## Process Change Notification

**Title:** MCC Introduces Auto-Soldering Process For SOD-123FL Package

**PCN#:** 080115-1

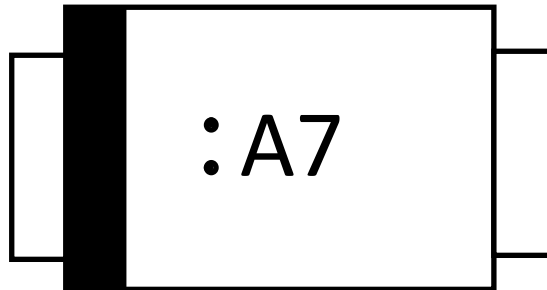
**Changed Part Identification:**

Devices with new process , identified with two dots on body ,see below for example:
